PUR-1751
ADDENDUM NO. 1
INVITATION TO BID

HAGERSTOWN REGIONAL AIRPORT
EXPAND/REHABILITATE TERMINAL BUILDING EAST

DATE: Thursday, June 12, 2025

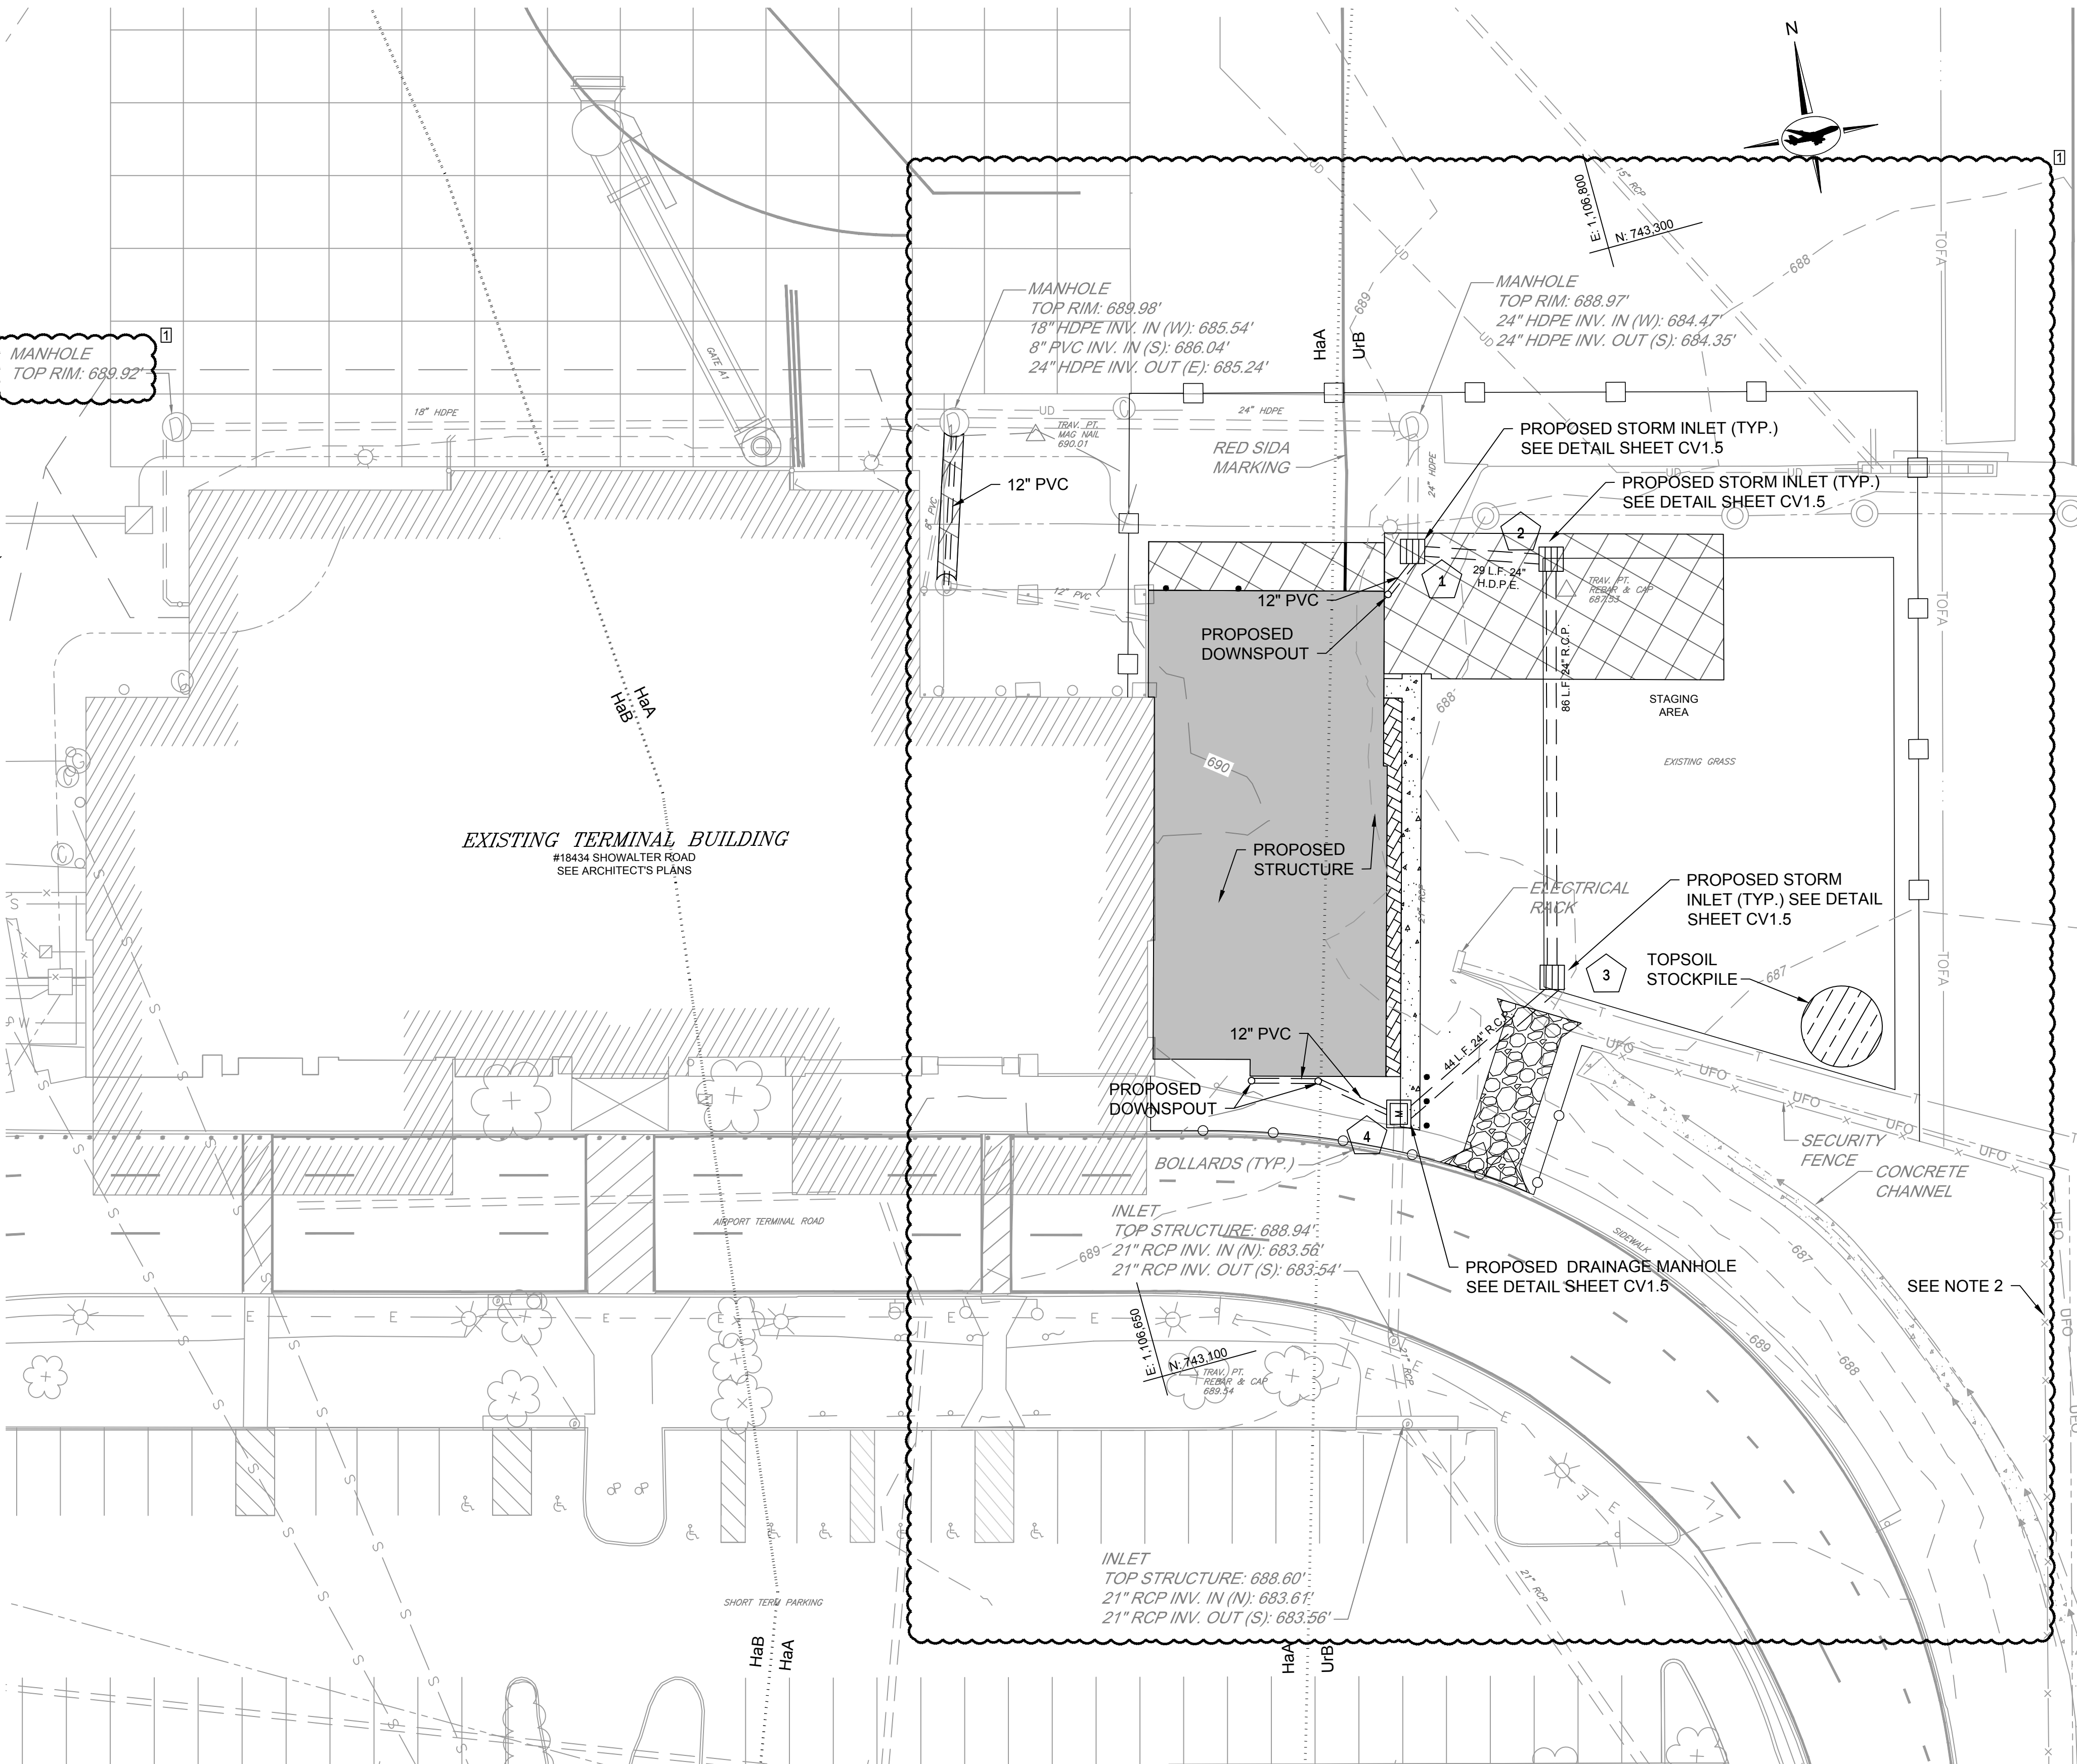
ITEM NO. 25: Sheet No. CV1.3 Site Plan:

REVISE: All leaders for proposed storm drain structures to call out detail sheet CV1.5.

REVISE: Proposed legend to include proposed manhole symbol, call out detail sheet CV1.5, and read PROPOSED BOLLARD (OWNER SUPPLIED MATERIAL – REBAR, CAGE, BOLLARD PIPE AND COVER).

REVISE: Existing security fence-line-to-remain during construction to ensure continuous security fence until proposed security fence is installed

GRADING AND SEDIMENT CONTROL PLAN

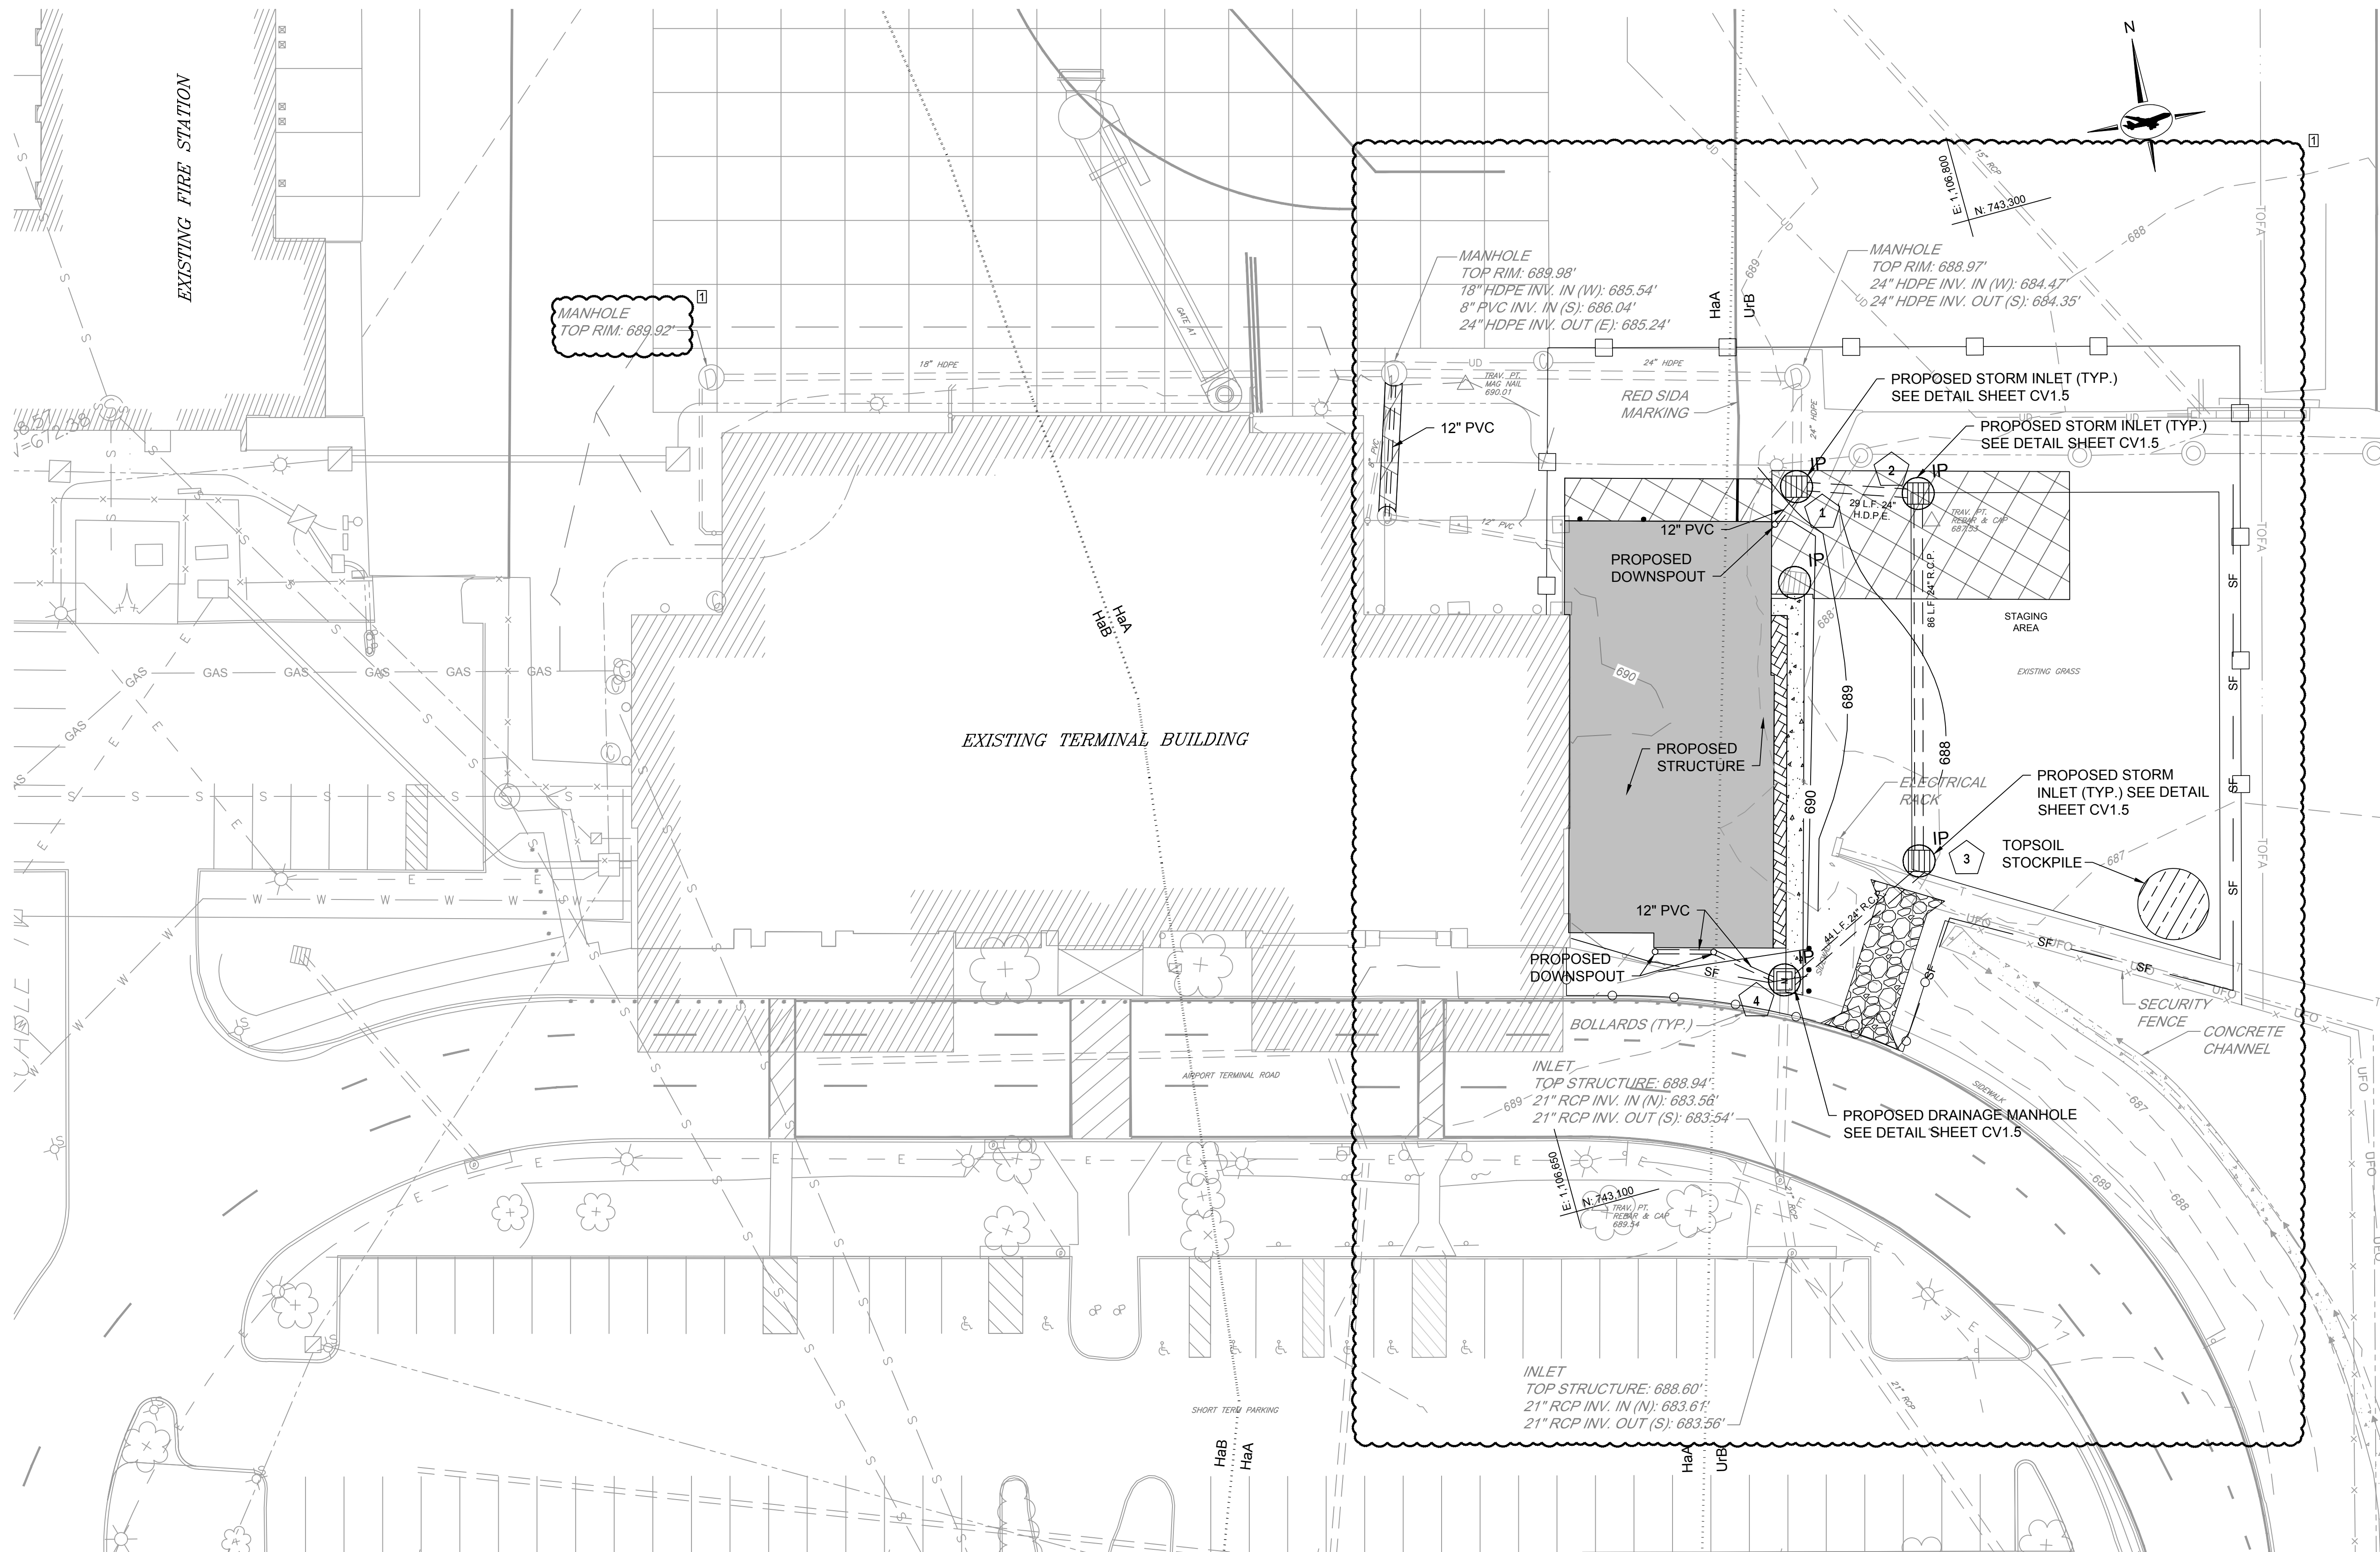
ITEM NO. 26: Sheet No. CV1.4 Grading and Sediment Control Plan:

REVISE: Text style and size for all leaders and text items.

REVISE: Proposed legend item for proposed storm drain structures to call out detail sheet CV1.5.

ADD: Proposed fence symbol to Proposed Legend.
